CALIFORNIA COASTAL COMMISSION

STAFF REPORT AND RECOMMENDATION ON APPEAL SUBSTANTIAL ISSUE DETERMINATION

Appeal Number: A-6-COR-16-0097

Project Description: Construction of a 235 sq. ft. public restroom facility with three stalls and storage space, a 1,000 sq. ft. plaza with showers and stairway, a mat foundation, and an approximately 30 ft. deep, steel sheet-pile bulkhead surrounding the project on three sides.

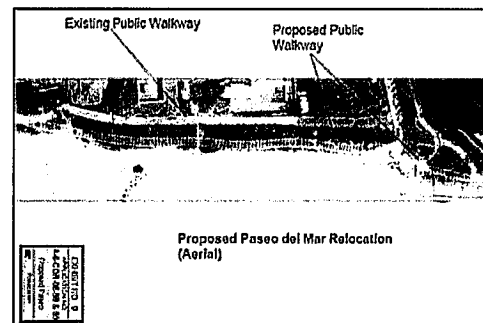
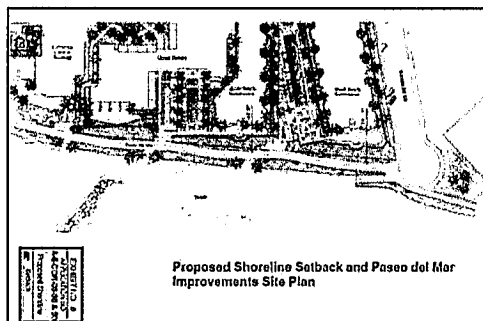
CCC-12 The comment states that structures such as restrooms should be considered expendable and designed to be removed or relocated if threatened. The City believes the proposed restroom facility is expendable. If it became infeasible to operate for reasons ranging from sea level rise to increased maintenance costs at the end of its useful life, the City would be able to easily remove

the proposed improvements. Although it is permanent, removal of the proposed facility—including the steel sheet-pile seawall—would be relatively quick and simple, taking no more than a week.

Figure 5-3 - Visual Simulation - North, Existing Elevation

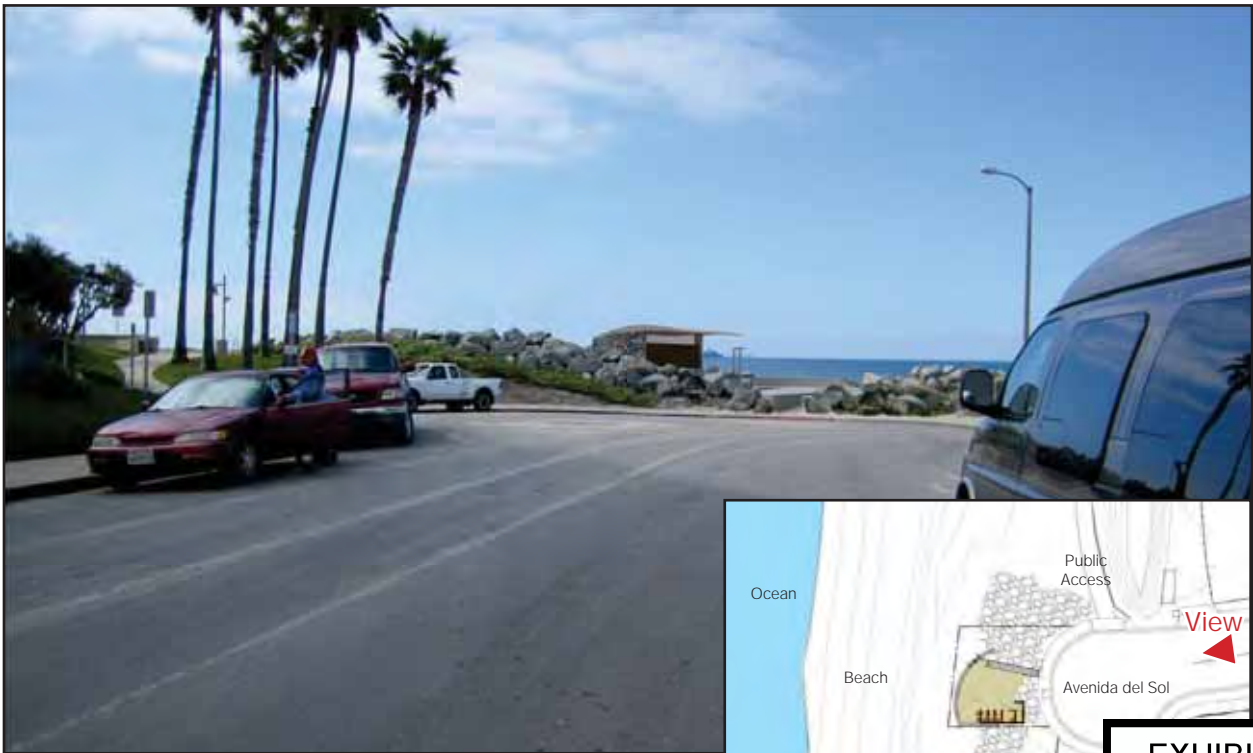
building and the roof would blend in with the surrounding rock riprap and beach sand, and the architectural cap of the bulkhead/sea wall would generally align with where the surf breaks. As shown in Figure 5-3 of the Draft EIR, the height of the building would be approximately the same height as the existing rock riprap, and the level of effort required by a viewer on Avenida del Sol to retain the view of the ocean would not be extensive. Therefore, public views of the ocean would not be substantially blocked.
